**APPLICATION OF WATERBRIDGE STATELINE LLC  
TO APPROVE SALT WATER DISPOSAL  
WELL IN LEA COUNTY, NEW MEXICO.**

**CASE NO. 24568**

**NOTICE OF REVISED EXHIBIT PACKET**

\* Revised as of August 26, 2024 Per Technical Examiner's Request

**Figure 1. Open Hole Log Snip of the Upper Confining Zone in the Lower San Andres Formation**

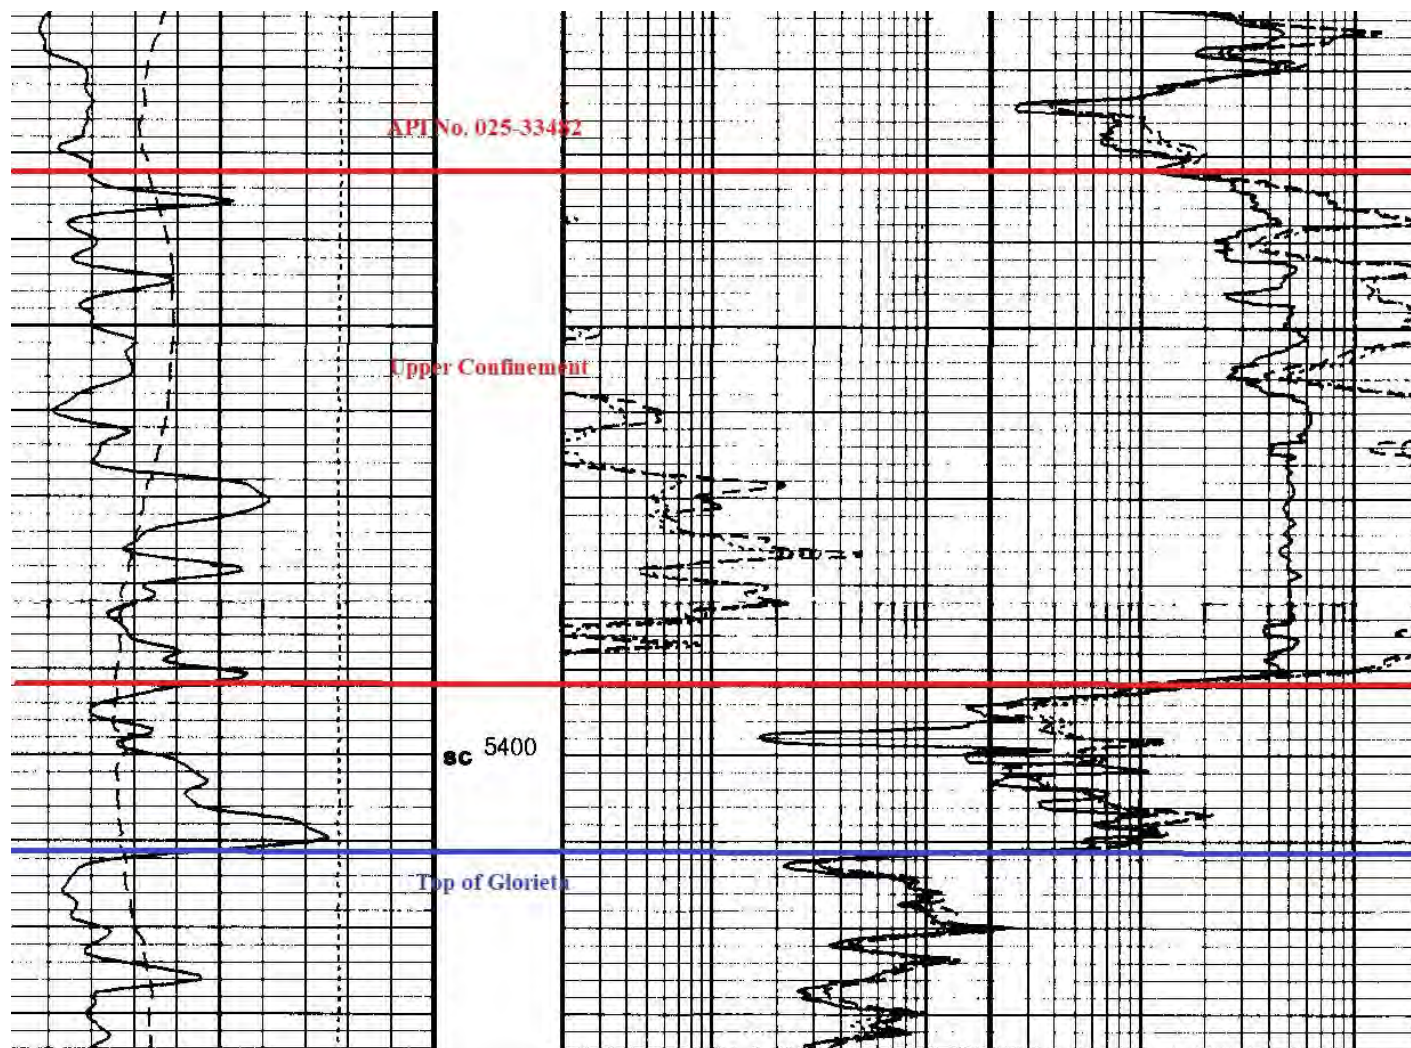
- Attachment 5: Revised to add a document entitled “Reservoir Characteristics at the FPNM SWD #1” which includes an analysis of porosity and resistivity of the upper and lower confining zones (see pages 35-36 of revised exhibit packet). This additional document also includes a statement from Waterbridge that Waterbridge will run a mud log on the FPNM SWD #1 as there is no current mud log data available within ½-mile. Waterbridge will provide that mud log to the Division.

The San Andres Formation is a shelf carbonate deposit composed predominantly of dolomite, and in the proposed development area, the lower San Andres Formation is a tight rock with low porosity and high resistivity values. **Figure 1** is a log snip of this upper confining zone of approximately 60 feet in the lower San Andres Formation. The lower confining zone is a tight sandstone unit within the Glorieta Sandstone, which also has low porosity development and high resistivity readings. The Glorieta Sandstone is a fine-grained, well-to-moderately sorted quartz arenite sandstone. **Figure 2** is a log snip of this approximately 30 feet of lower Glorieta Sandstone.
